HARBOR INTERLAKE APARTMENTS
3651 INTERLAKE AVENUE NORTH

DESIGN REVIEW
MEETING DATE : MARCH 17 2014
DPD #3014898

DEPARTURE REQUEST #1 MASSING DIAGRAM COMPLIANT

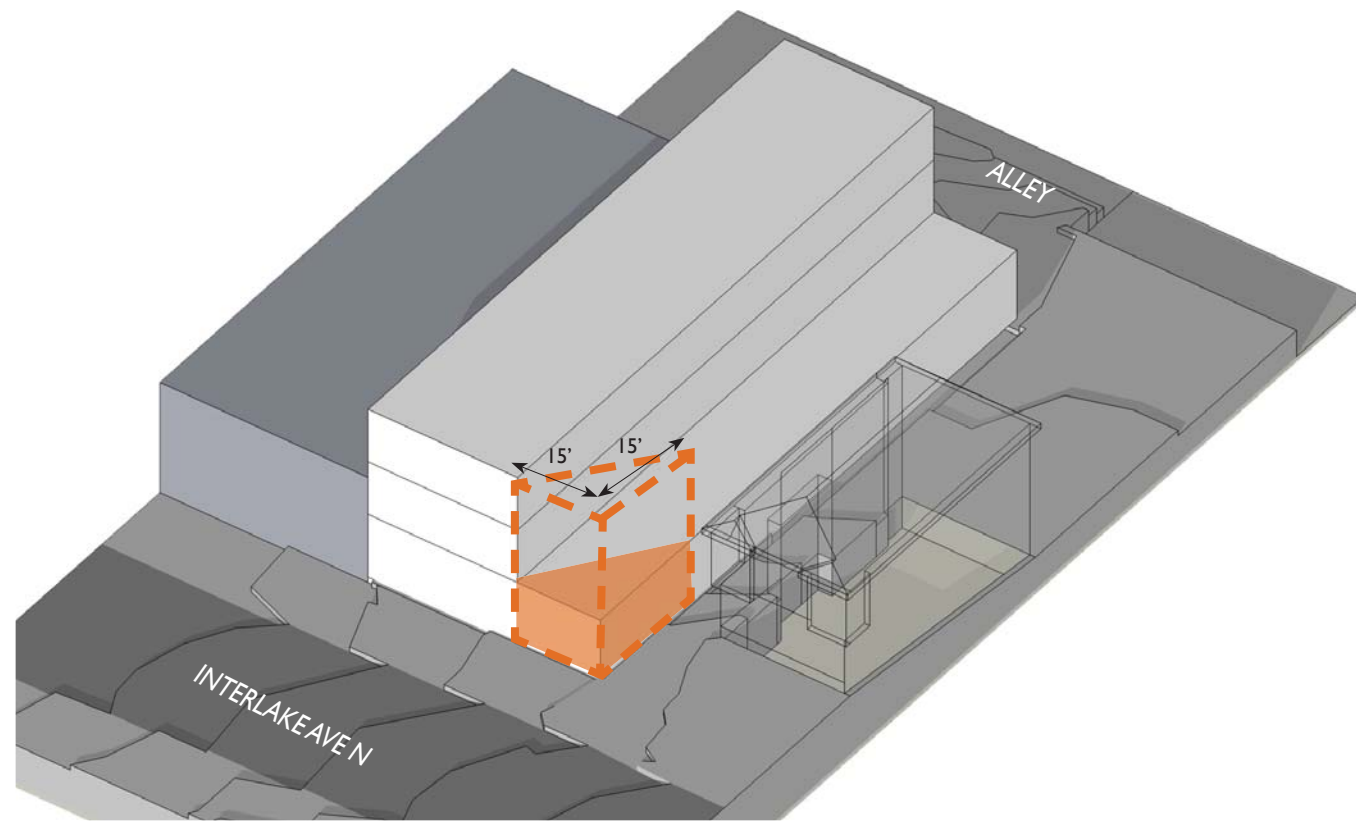
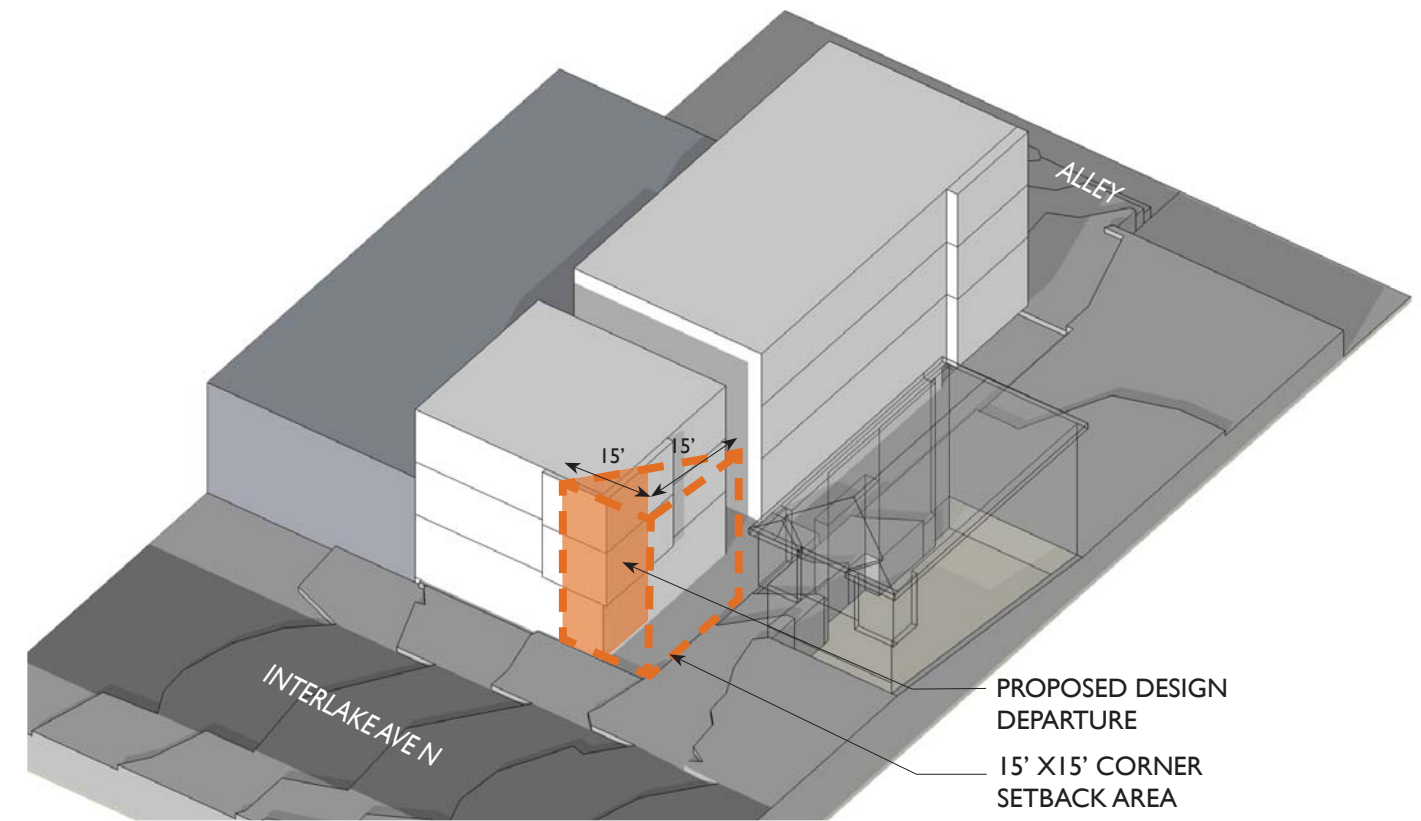
2. Setback Requirements for Lots Abutting Residential Zones (SMC 23.47A.014.B.1): The Code requires a 15' by 15' triangular area setback where a NC zoned lot abuts the intersection of a side and front lot line of a lot in a residential zone. The applicant is proposing a 7' minimum setback for a portion of, the full building face

CI-30 ZONING CODE	REQUIRED STANDARD	REQUESTED DEPARTURE	JUSTIFICATION FOR DEPARTURE (How it exceeds the intent of relevant design guidelines)
#1 ABUTTING SIDE SETBACK SMC 23.47A.014.B	At the NE corner along Interlake Ave N. No development within a 15' x 15' triangle abutting a residential zoned lot	(a) 9'-2" x 9'-2" encroachment into the 15' x 15' setback triangle (b) This applies at elevation above 1st story only where there is a cantilevered bay. The area below this that abuts the front lot line is 1'-2" wider	(C-2) Architectural Concept and Consistency (a) Maintain integrity of the basic form of the "shophouse" block at exposed corner. Facilitate cantilevered bay above which references historical structure next door. Preserve legibility of the design concept.

DEPARTURE REQUEST #2 MASSING DIAGRAM COMPLIANT

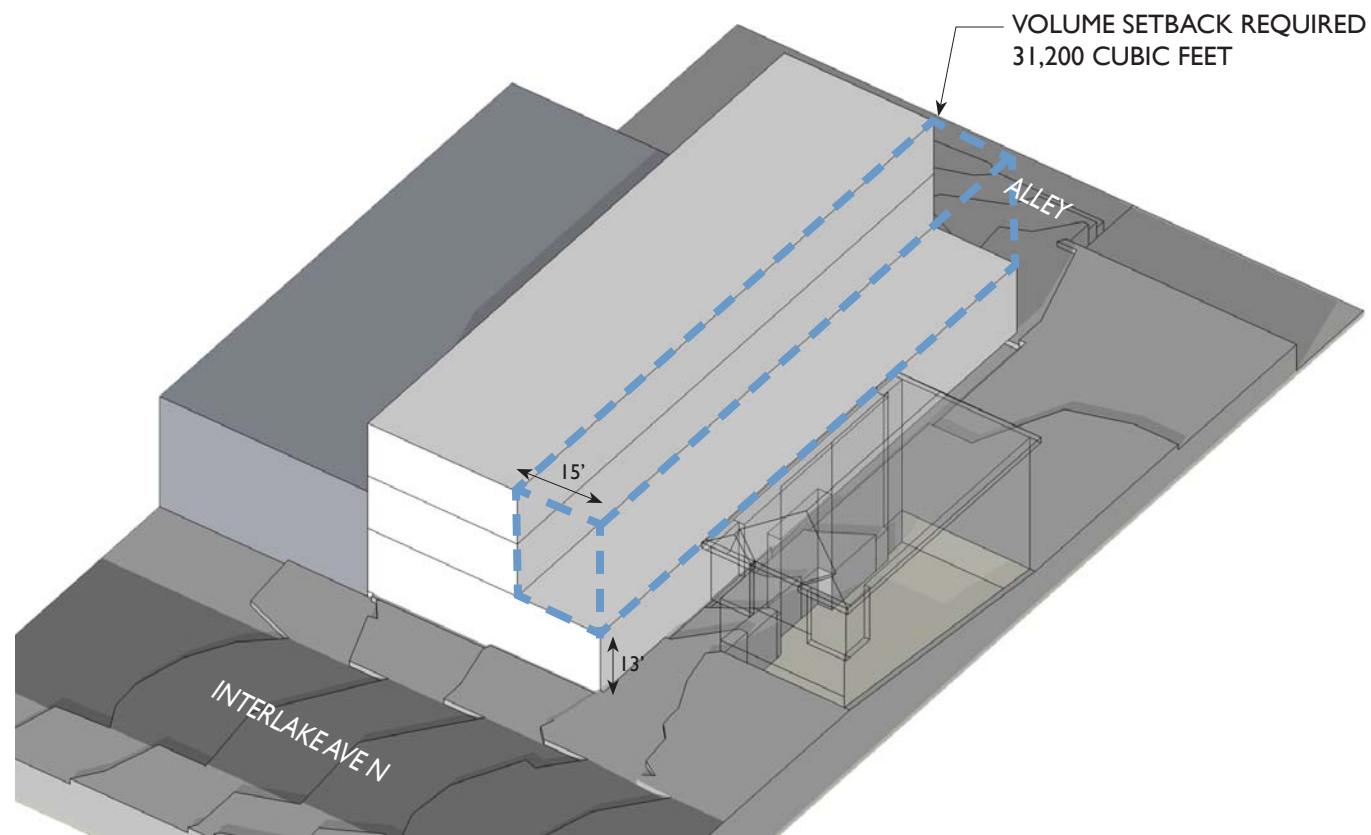
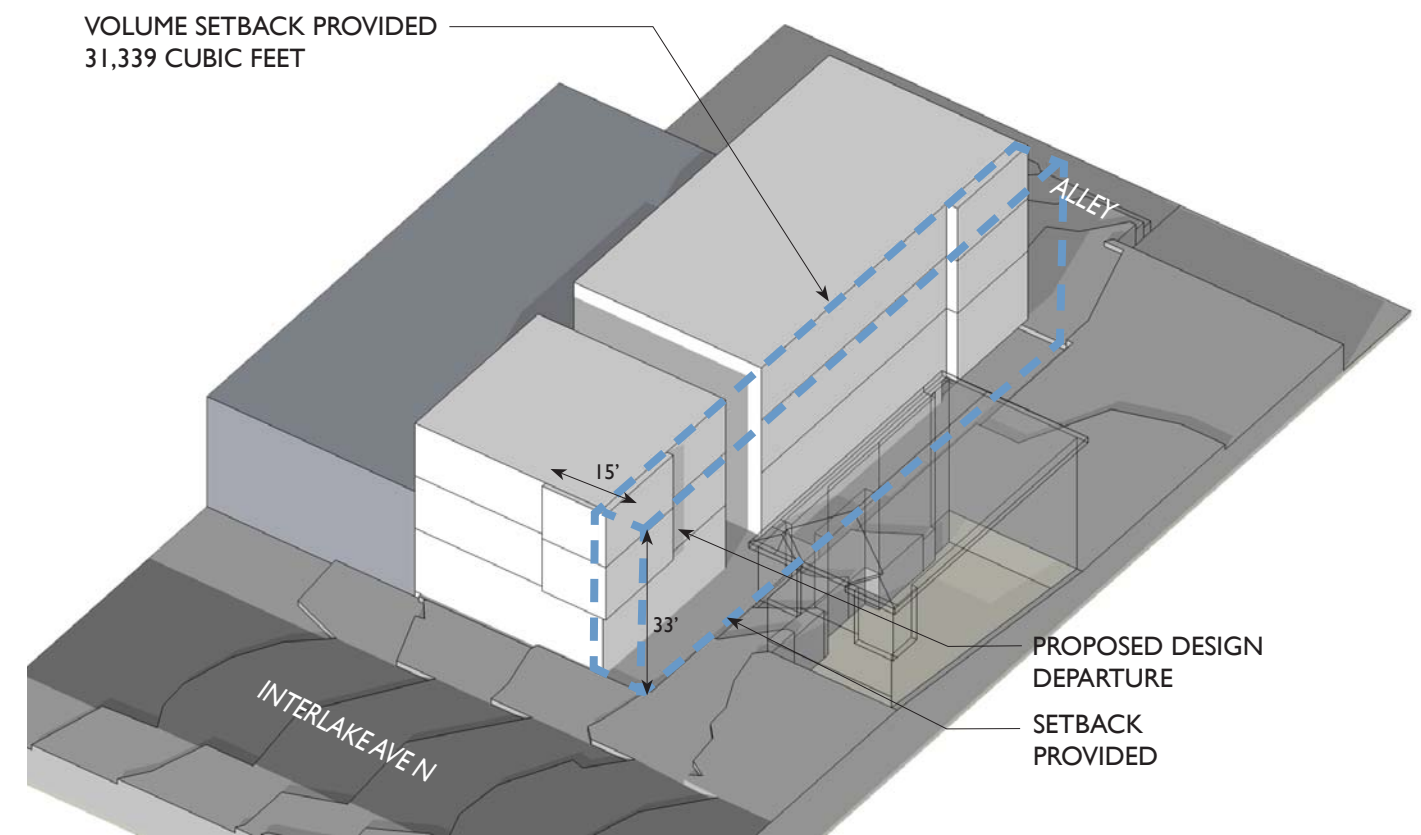
1. Setback requirements for Lots Abutting Residential Zones (SMC 23.47A.014.B.3.a&b): The Code requires structures along a rear or side lot line that abuts a residential zoned lot to be set back 15' for portions of the structure above 13' in height up to 40', and an additional 2' for every ten feet of height above 40'. The applicant proposed a 7' setback from the north lot line for the full building face at the eastern and western portions of the structure and a 10' setback for the full building face for the middle section of the structure.

CI-30 ZONING CODE	REQUIRED STANDARD	REQUESTED DEPARTURE	JUSTIFICATION FOR DEPARTURE (How it exceeds the intent of relevant design guidelines)
<p>#1 ABUTTING SIDE SETBACK SMC 23.47A.014. B3a & b</p>	<p>At the north property line a 15' setback is required from a rear or side lot line abutting a residential zone above 13' in height.</p>	<p>(a) Sideyard with setbacks (from ground to sky) that vary from 7' to 10' and 8'</p>	<p>(A-5) Respect for adjacent sites (b) Creates overlook condition over existing rear yard not mediated by any distance. We believe proposed design better meets intent of guideline above. (E-2) Landscaping to Enhance the building and/or Site (c) Zero-lot-line condition allowed by current standard does not accommodate landscaping at/or near grade. Proposed design incorporates extensive landscape screening at north lot line. (A-7) Residential Open Space (d) Create opportunity for development of ground-level open space. There is a potential for a yard-to-yard relationship only on north side of subject lot.</p>

EAST ELEVATION OPTION STUDY

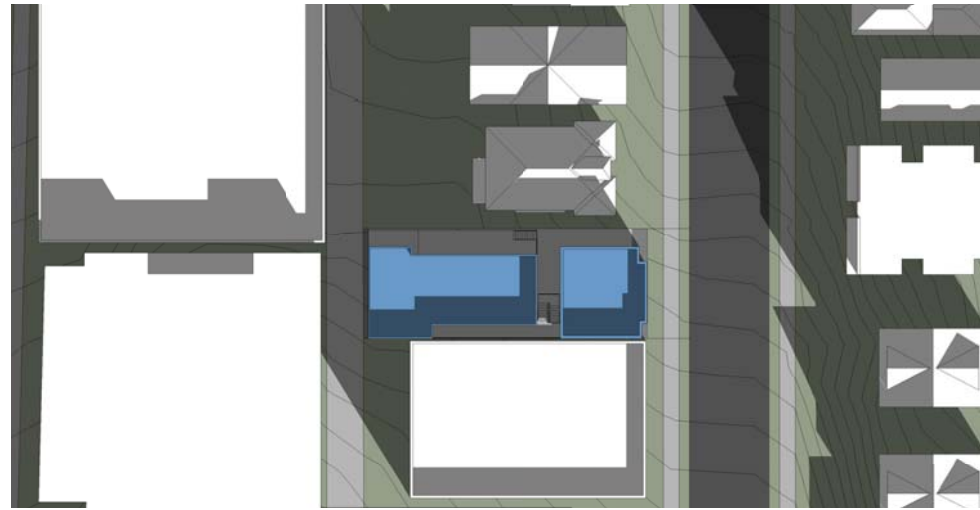
The Board expressed concern that the proposal is not presenting a clear architectural concept. The modern industrial look presented in the character sketches is interesting but does not read as residential.

- The idea of transition from commercial to residential use should be expressed. (B-1)
- The building should not have a strictly commercial vocabulary. Balance the commercial live/work unit at grade with the residential use of the structure and neighborhood. (A-5, C-1, C-2)
- Consider providing modulation on the south elevation above the existing structure to the south. (C-2)

The design approach is to incorporate a contemporary commercial storefront at the ground floor Live/Work unit and to integrate elements of the neighboring residential structures in both material and form to create a bookend to the warehouse and a backdrop to the house to the north (B-1). The building is set back from the east property line to provide a landscaped area and a widened sidewalk adjacent to the commercial entry. The main residential building entry is located along the north property line adjacent to the house (A-5, C-1, C-2). Two secondary residential entries flank the commercial Live/Work space and provide access to the two apartment units above the commercial space.

The design team considered modulation of the south wall above the neighboring warehouse, but resolved that an architectural treatment of randomly placed colored CMU block of the south facing wall maintained

the fire separation between structures and provided some architectural interest (C-2).
